Division of Water Pollution Control ANNUAL FACILITY INSPECTION REPORT

for NPDES Permit for Storm Water Discharges from Separate Storm Sewer Systems (MS4)

Report Period: From March, 2015 To March, 2016

Name: Village of Channahon Mailing Address 1: 24555 S. Navajo Drive

DATE: 09/18/13	SCALE: 1"=30'	PROJECT MGR: DESIGNED: GGA	PROJECT MGR: CHECKED: MAW	SHEET: 7 OF 9	VP#8 13-28
REVISIONS					
A					
B					
C					
D					
E					
F					
G					
H					
I					
J					
K					
L

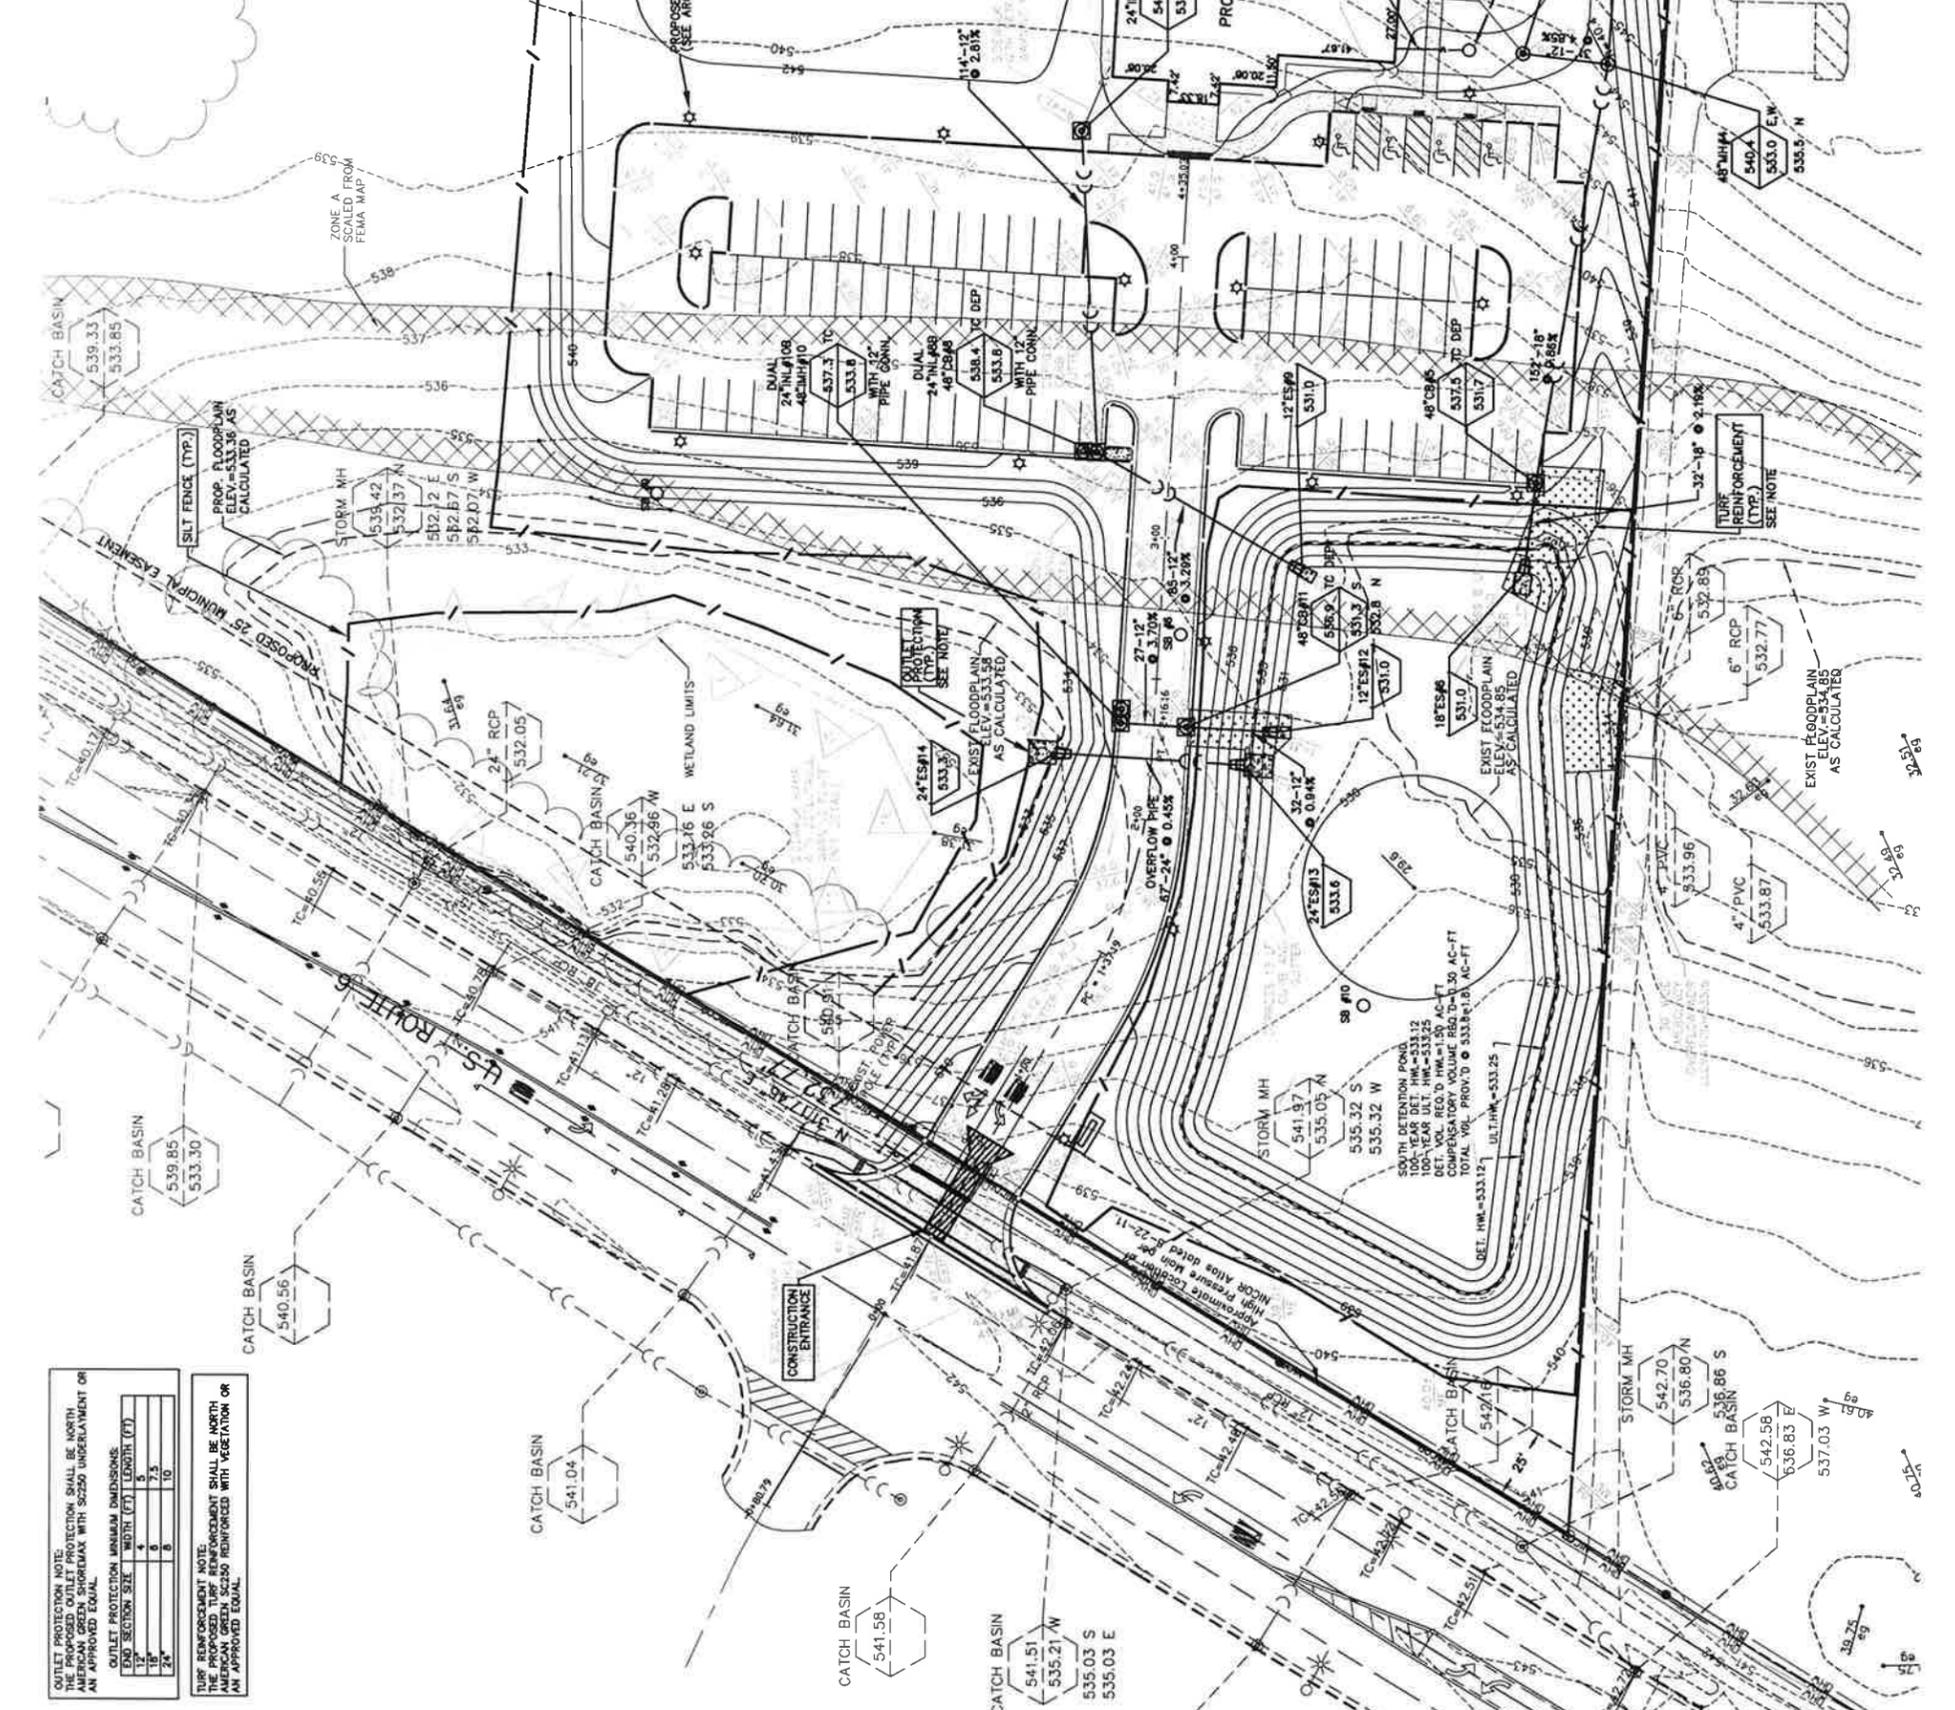
3. Utility and Erosion Control Plan, Sheet 7

- 3.1 Per Village record drawing submittal guidelines (including bold type): **'Start with VOC Approved for Construction engineering plans and add asbuilt data. Simply strike through proposed data and provide asbuilt data adjacent to it; asbuilt data should be easily distinguishable. All Approved for Construction (AFC) data should be shown.'**

This sheet does not match approved engineering plans. See attached.

- 3.2 Previous Comment: *Provide asbuilt sanitary service information including service pipe location, sizing, inverts, slopes, cleanouts, and septic field boundary.*

- 3.3 Previous Comment: *Provide asbuilt utility crossing information including any new crossings.*

- 3.4 Previous Comment: *Provide asbuilt top-of-foundation elevation.*

VOC: Per Village record drawing submittal guidelines: 'Show required asbuilt data on all sheets which contain corresponding proposed data...' Please strike out proposed T/F elevation and provide asbuilt elevation on this sheet.

- 3.5 Previous Comment: *When asbuilt information matches proposed, cross out proposed and show asbuilt data.*

VOC: Structures INL-1, MH-1 and CB-11 have second inverts which do not have asbuilt elevations; the asbuilt elevations provided appear to specify one direction. An asbuilt pipe slope between MH-4A and MH-4 is not provided. The pipe slope between INL-7 and INL-8 is correct, but not shown as asbuilt.

Sediment Infiltration

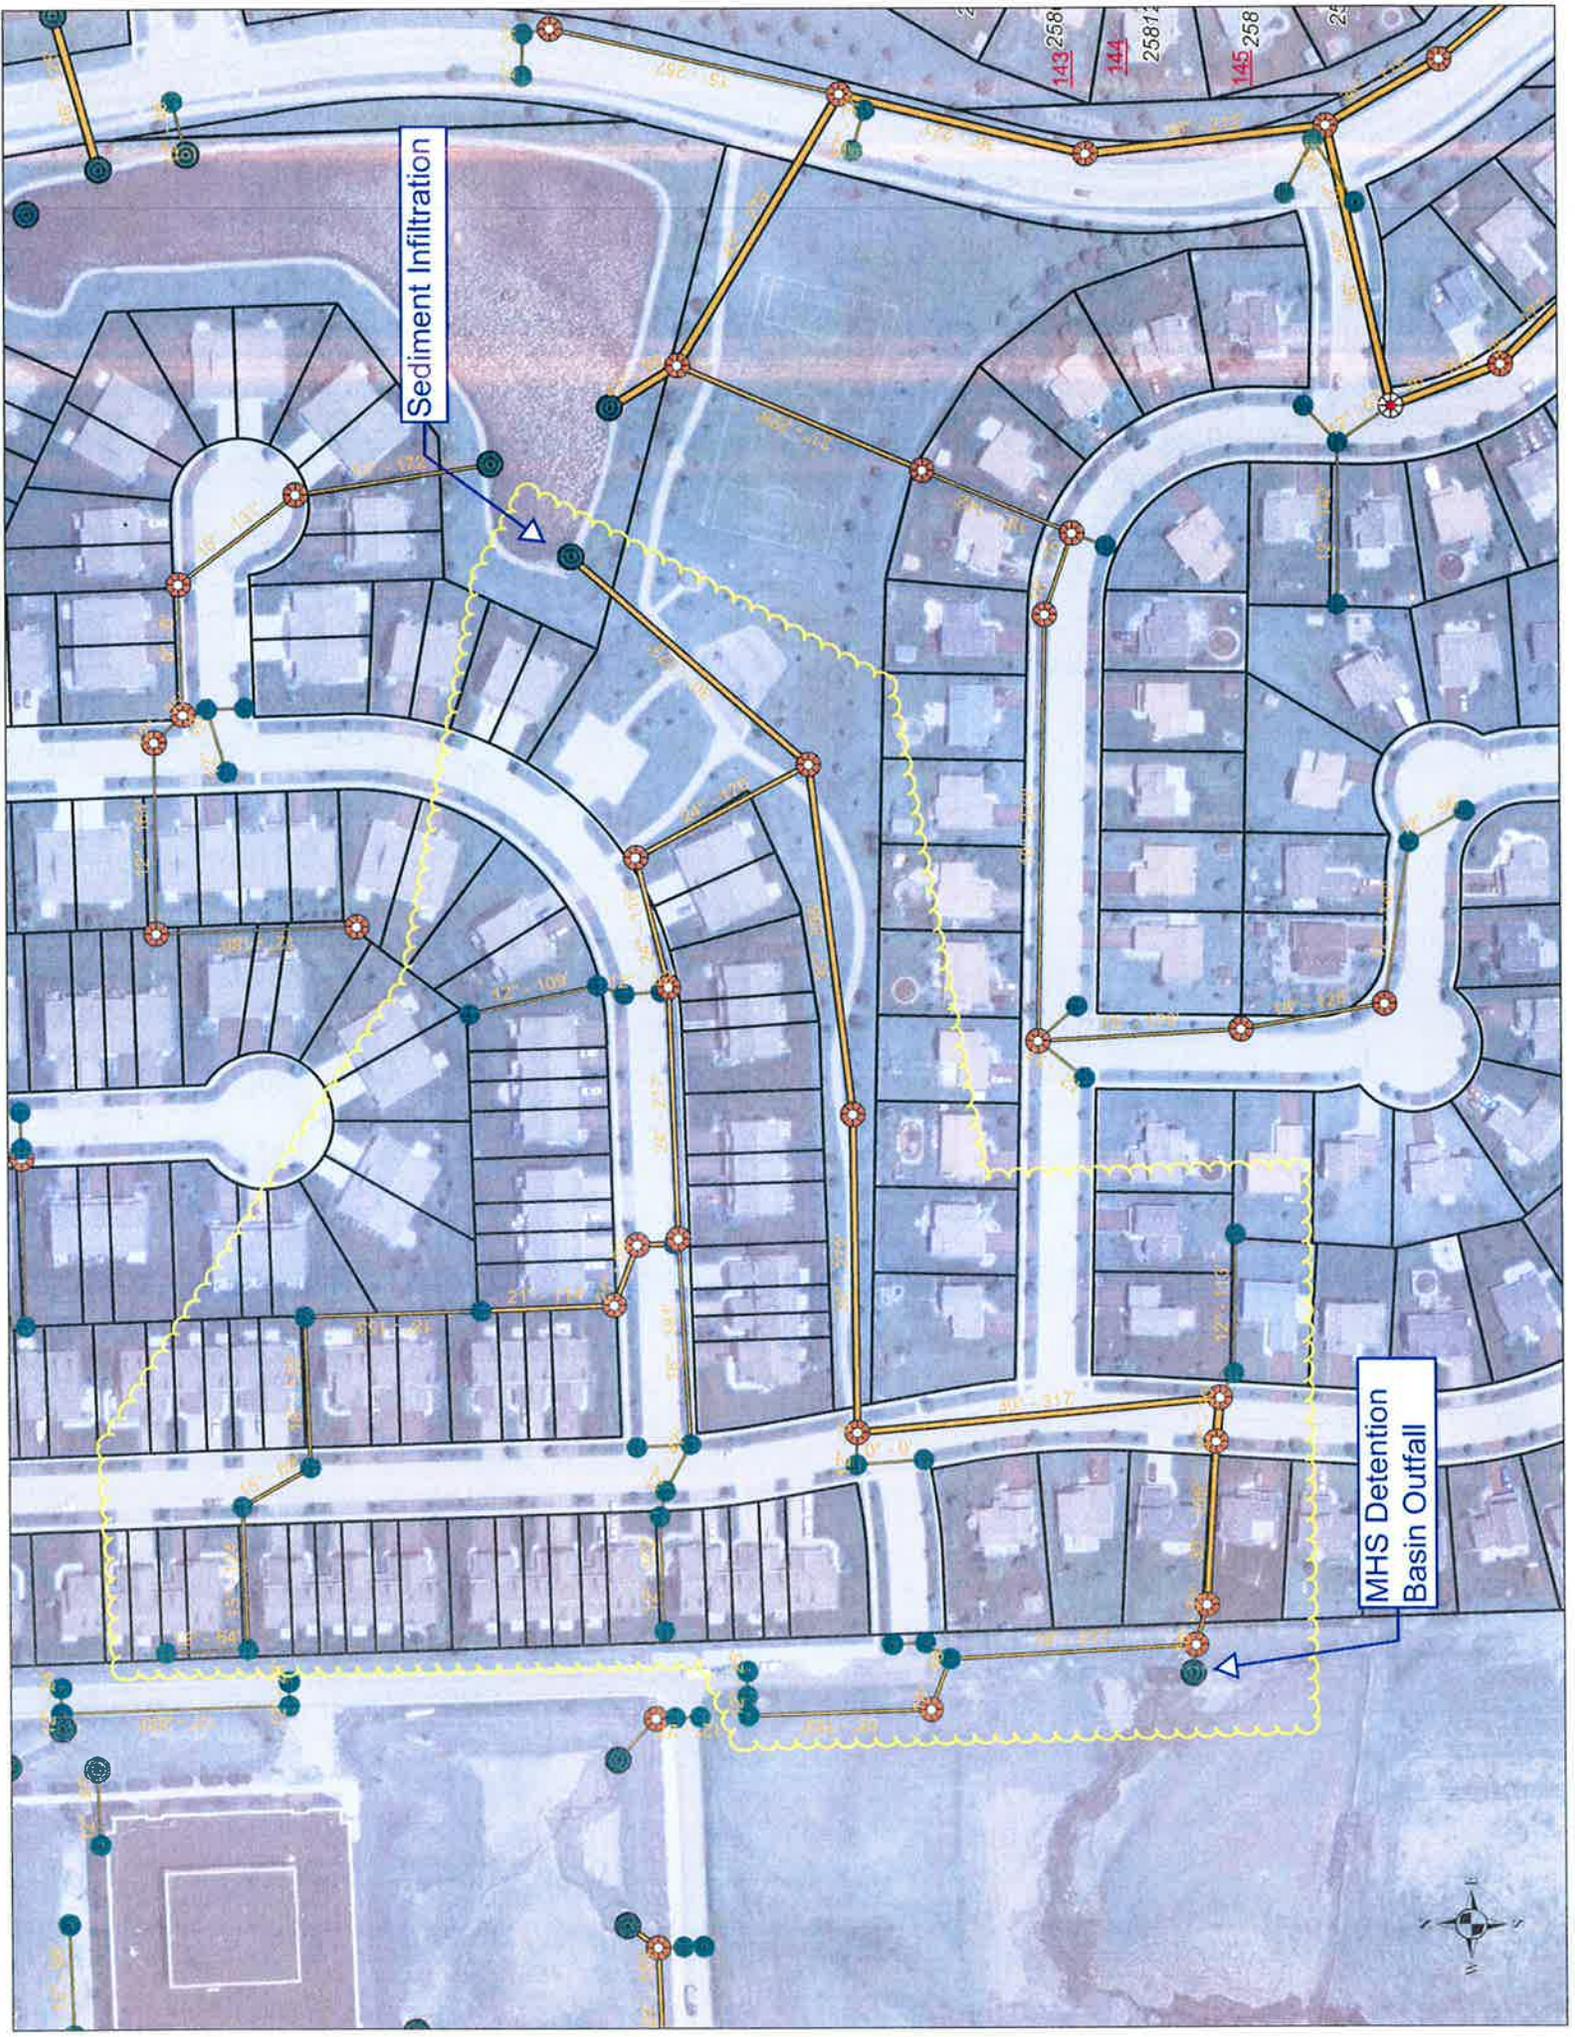
- The current detention basin ground cover is weeds which, by their nature, are not an adequate vegetative sediment control. Please remove existing ground cover and replace with a suitable detention pond ground cover. Although design plans called for the basin to be planted with Kentucky Bluegrass, the Village is open to discussing other forms of permanent ground cover which might require less maintenance.

- Per approved engineering plans, 15' square vegetative buffers are required around all farm field storm structures tributary to the MHS basin. However, as seen in attached photos, a herbicide is being used to kill vegetation around these structures as well as around the top of the basin. The farmer and/or high school must stop this practice immediately and into the future.
